Metro Martin Place

Sydney Metro and Over Station Development Design Review Panels

DRP #06

7 August 2018

FORM AND MASS

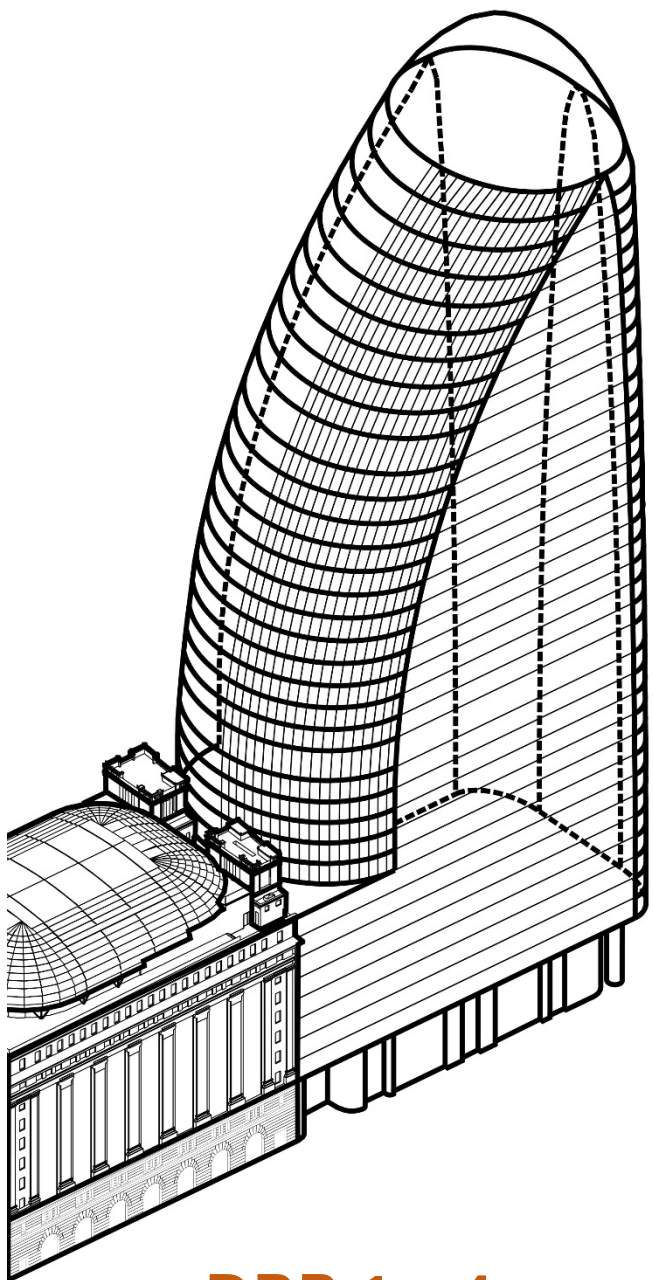
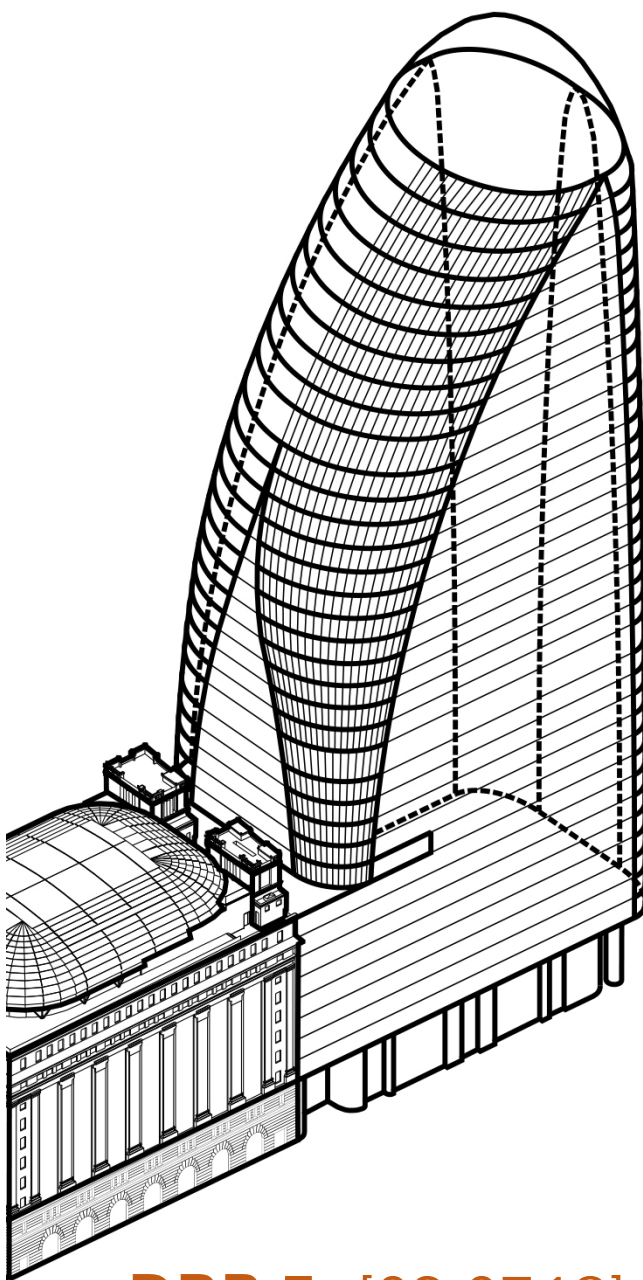
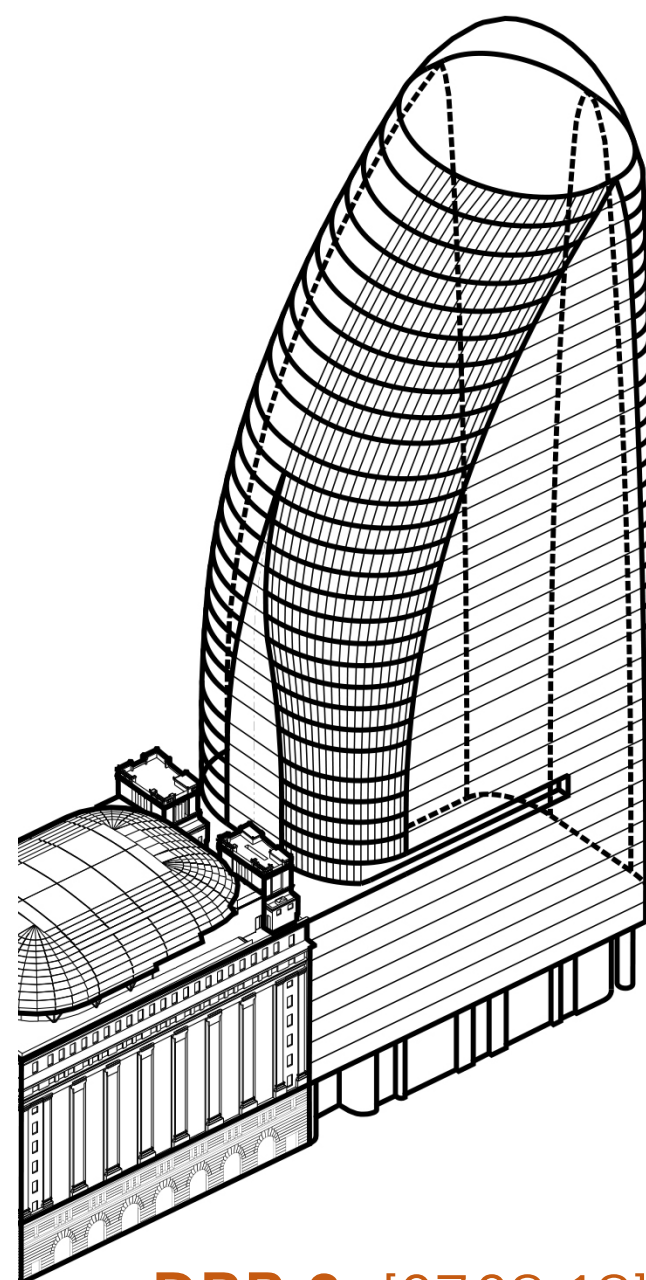
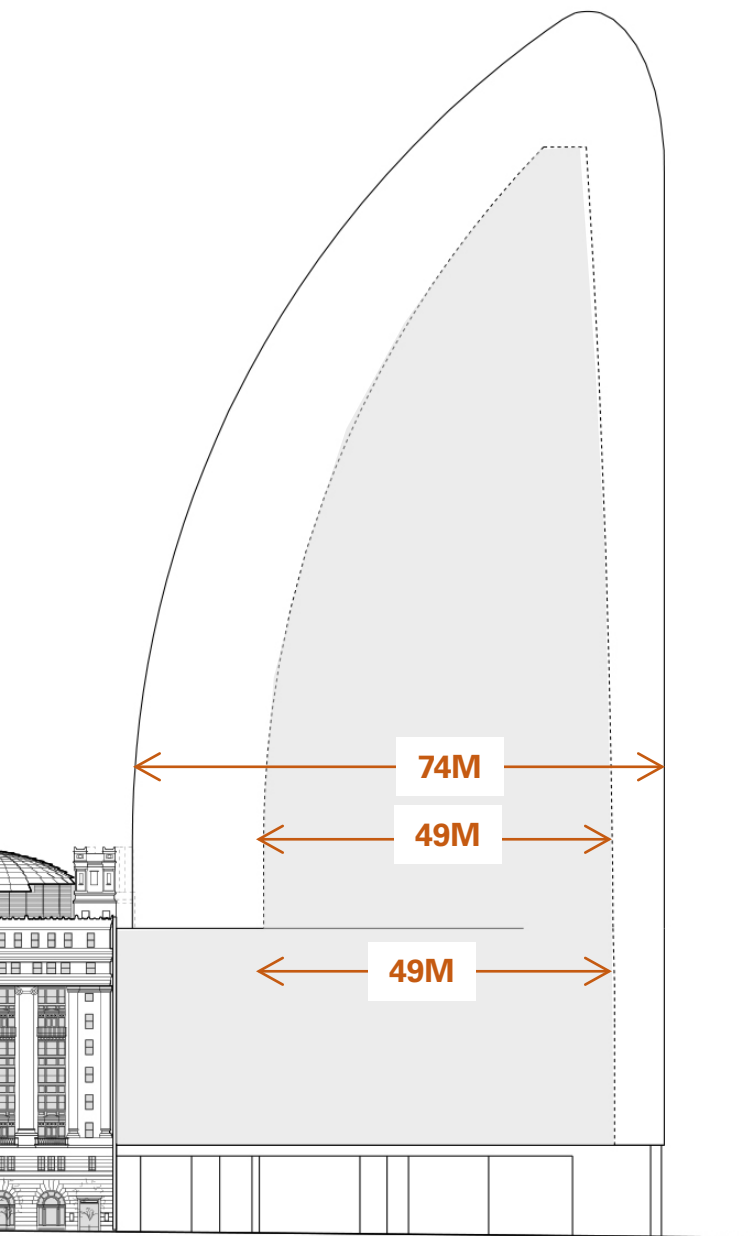
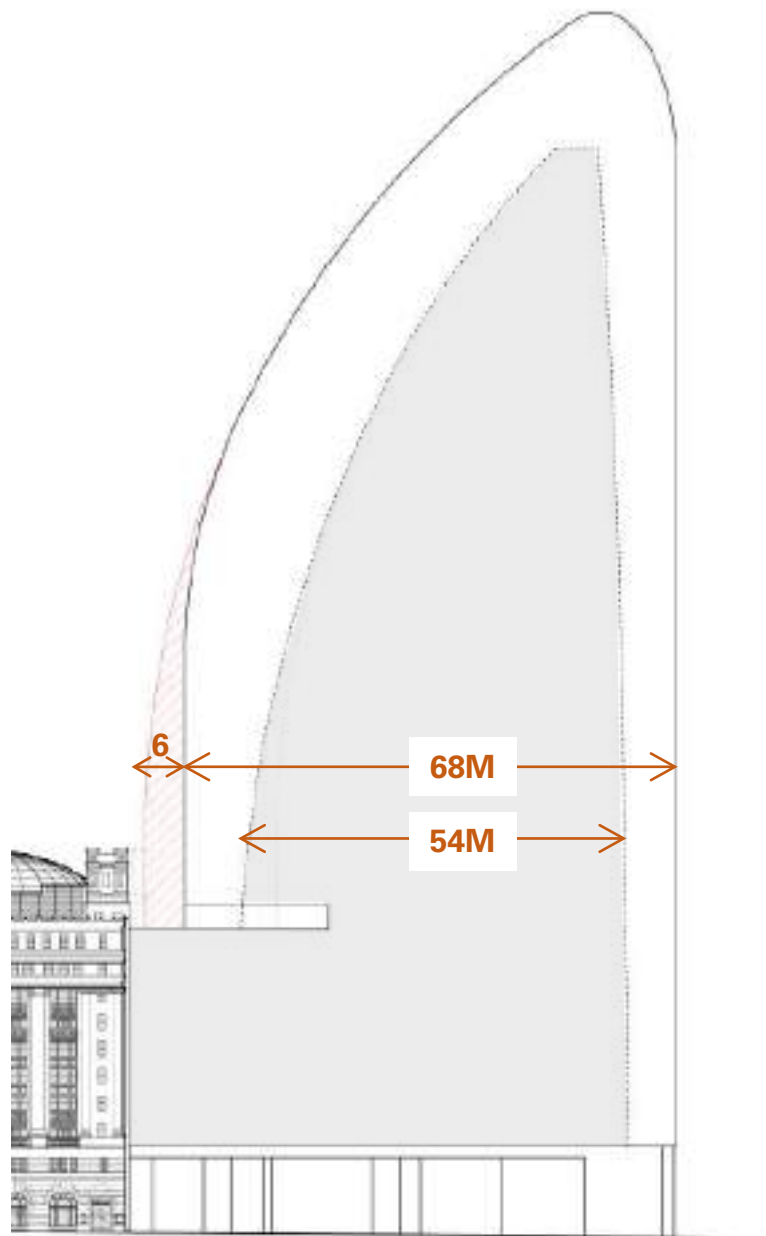
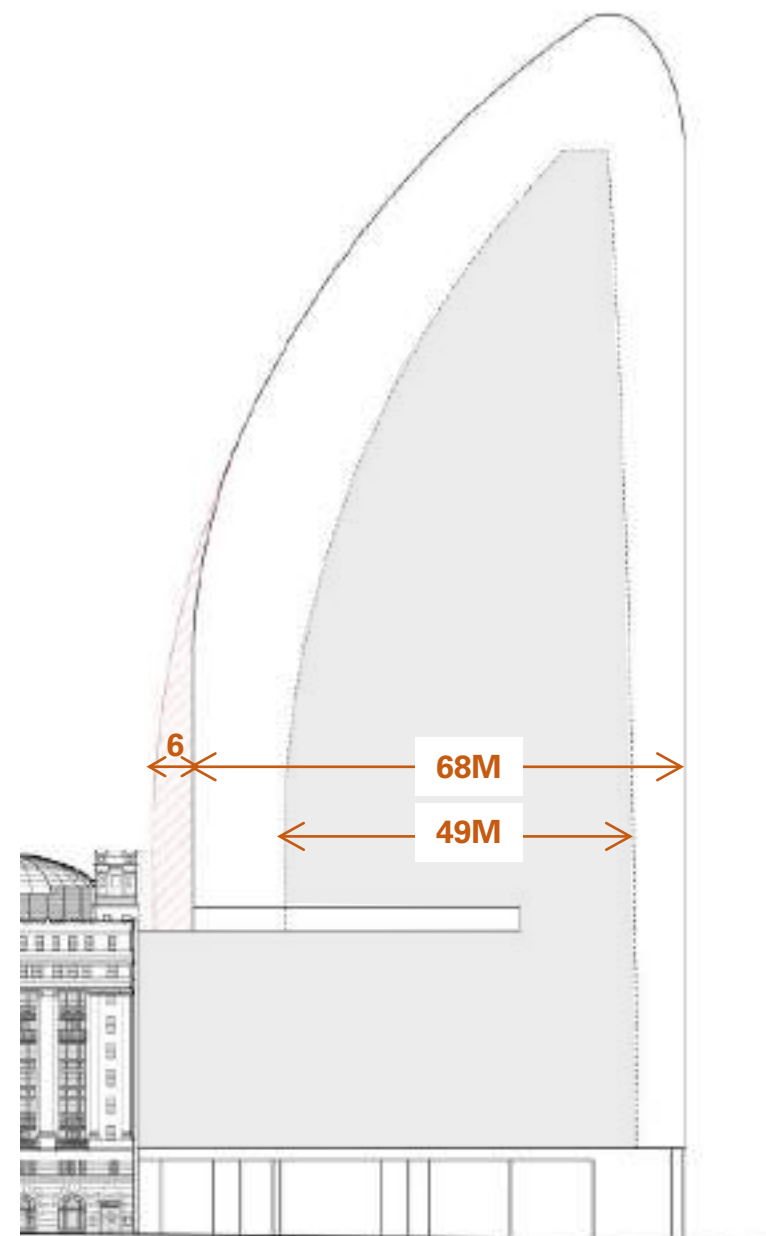
The OSD DRP has recommended reconsideration of the North Tower's form and mass, and particularly narrowing at the base.

JPW presentation, presented under separate cover, responds to the OSD DRP's advice and recommendations regarding the North Tower's form and mass, including:

- narrower base
- extent of flat surfaces on the eastern and western elevations
- tower geometry
- setbacks to 50 Martin Place

LEVEL 10 TERRACE

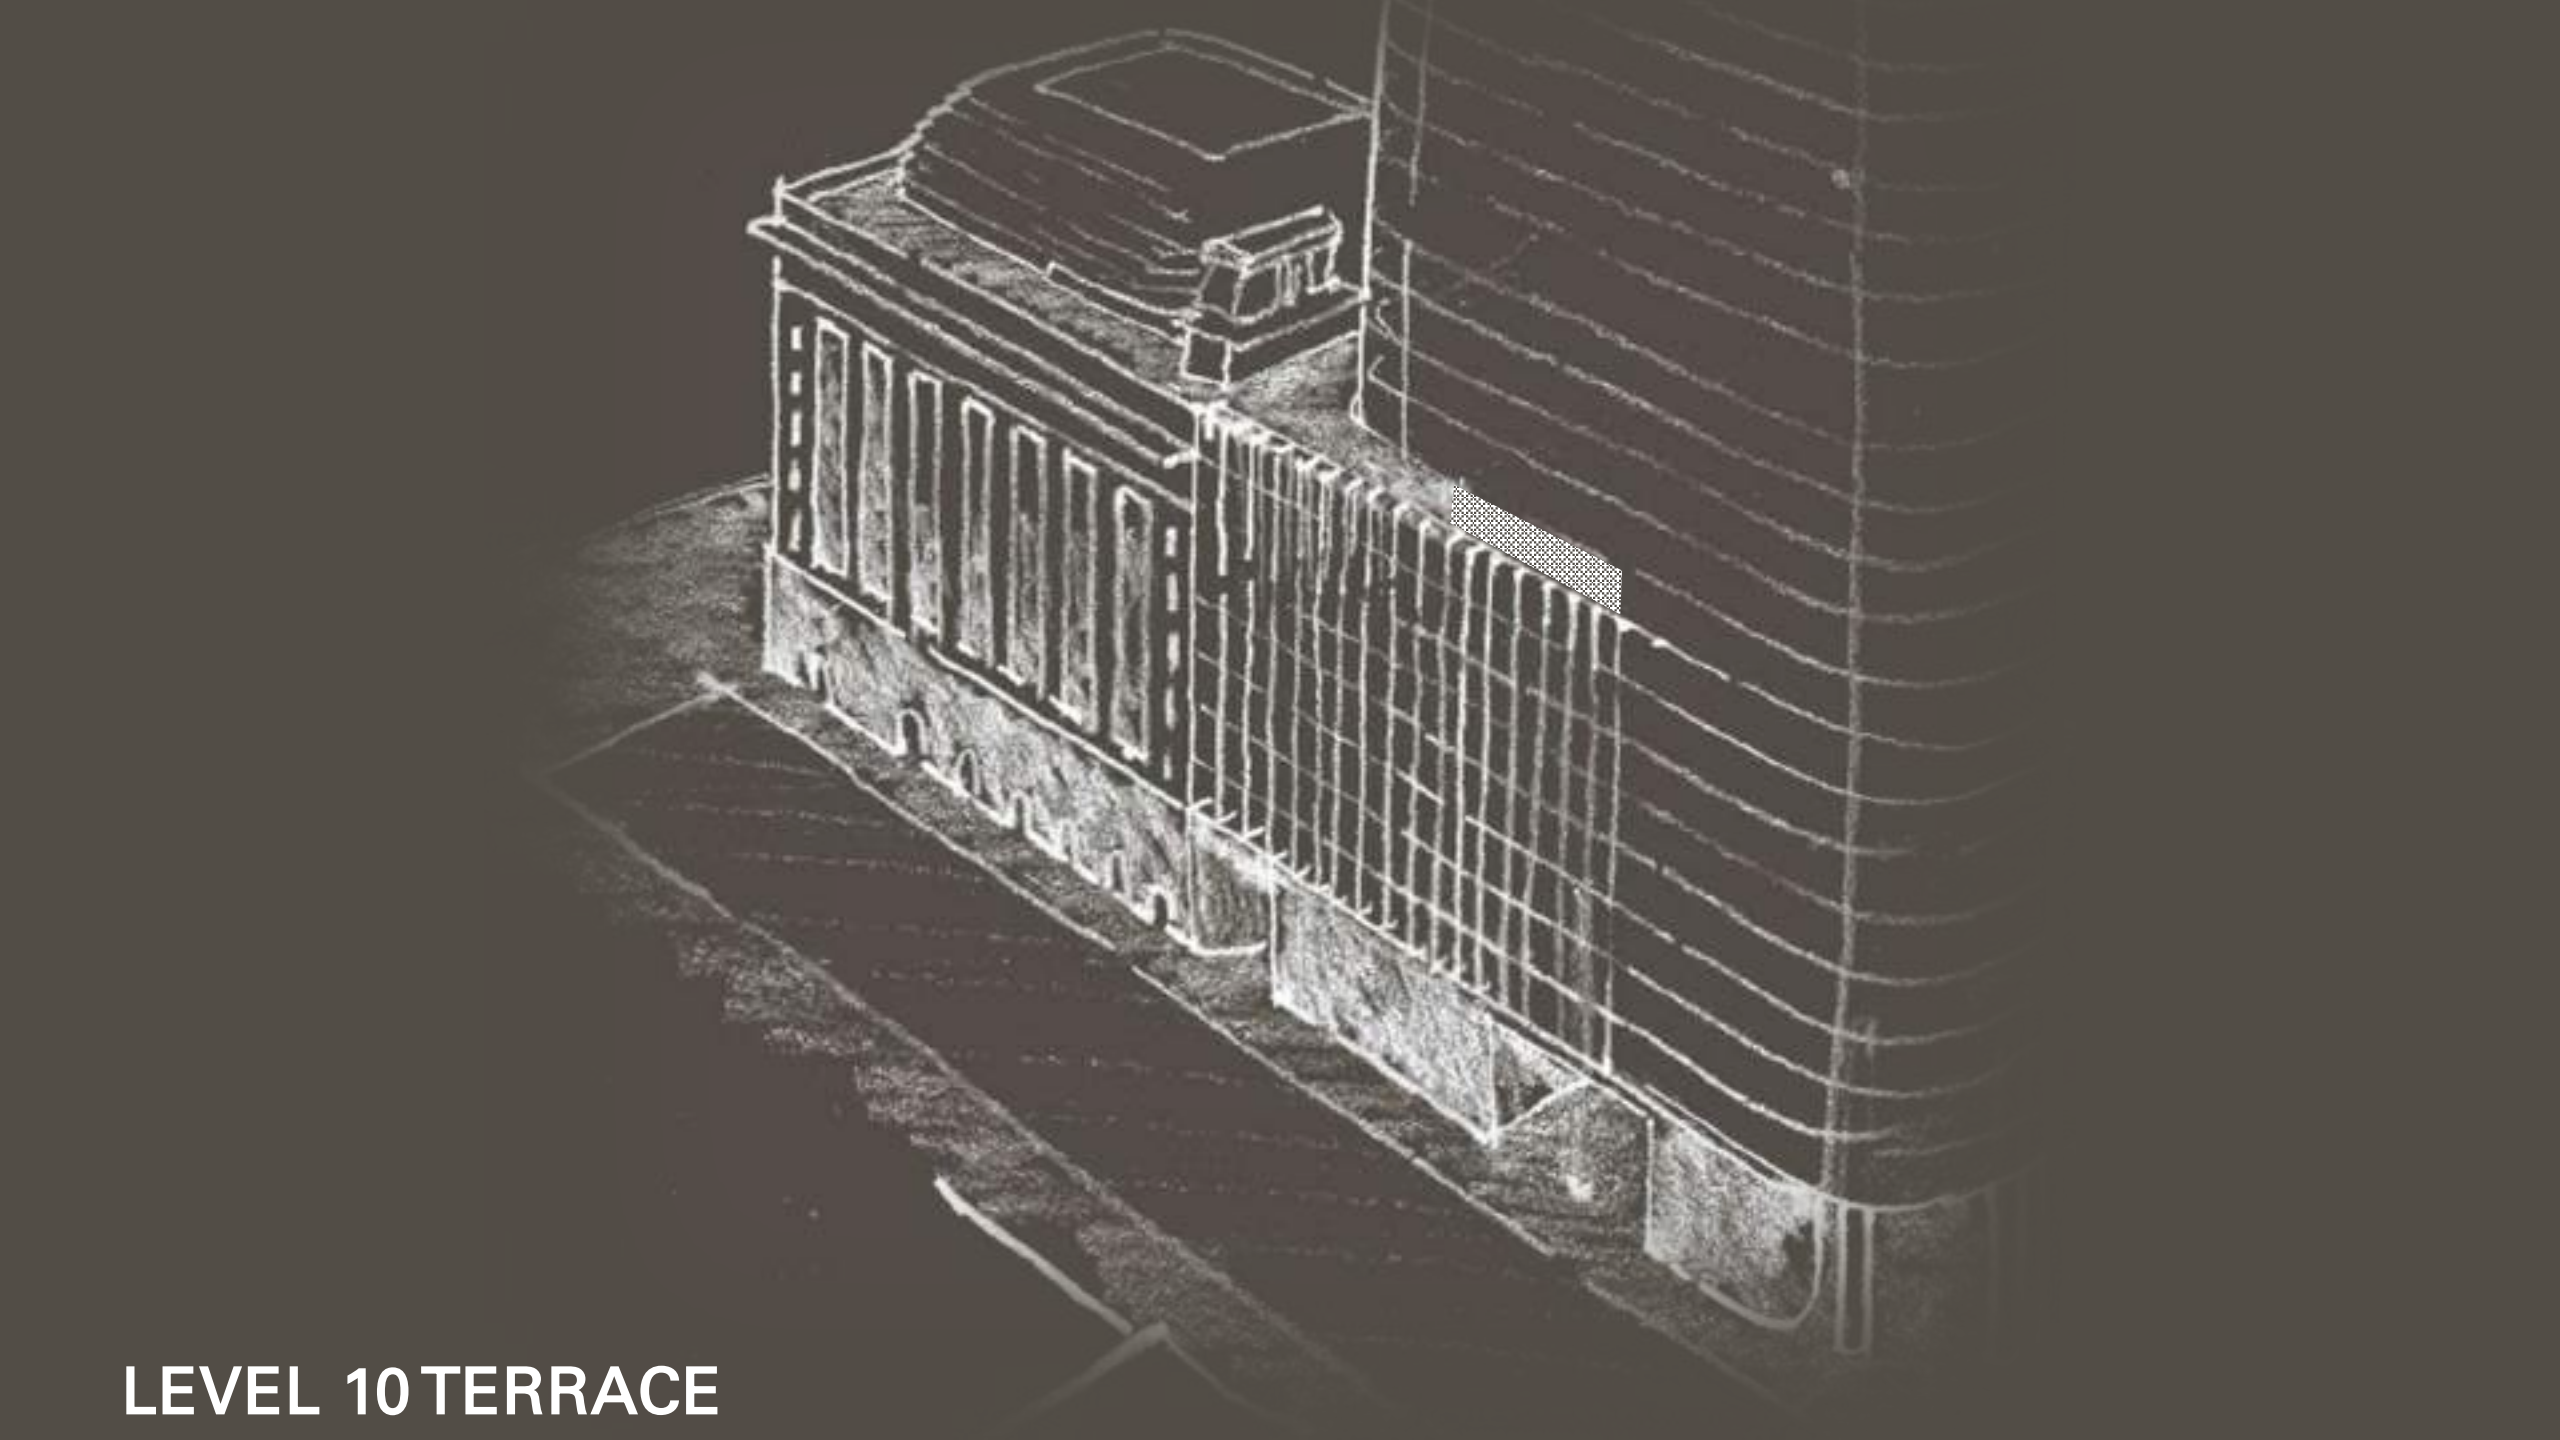
The OSD DRP has recommended reconsideration of the Level 10 terrace and requested more details on materials.

JPW presentation, presented under separate cover, responds to the OSD DRP's advice and recommendations regarding the North Tower's architectural expression, including:

- revised Level 10 terrace depth
- shading elements on tower and particularly southern façade
- proposed materials for each component of the tower
